ENLARGED PLAN EXAM ROOM (TYP.)

Drawing Title ENLARGED FLOOR PLANS	Project Title GERIATRICS-WOUND CARE CLINIC	Project Number 580-17-100 Building Number 100	Office of Construction and Facilities Management  Department of Veterans Affairs
Approved: Chief Engineer/Division Manager	Location VA Medical Center, Houston, TX Date 1/25/2017	Drawing Number ASI-1 Dwg. of	
	Checked ML	Drawn ML

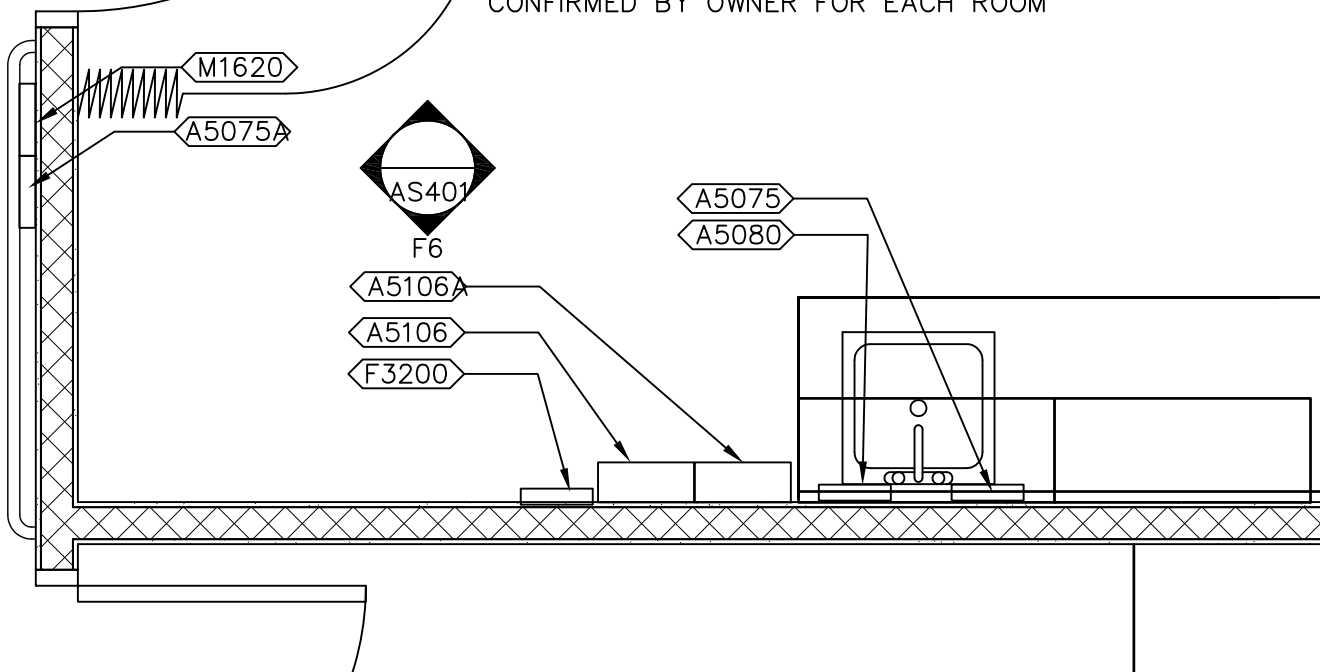
CURTAIN TRACK —
TYP ALL EXAM ROOMS

LOCATION OF FURNITURE & ACCESSORIES TO BE
CONFIRMED BY OWNER FOR EACH ROOM
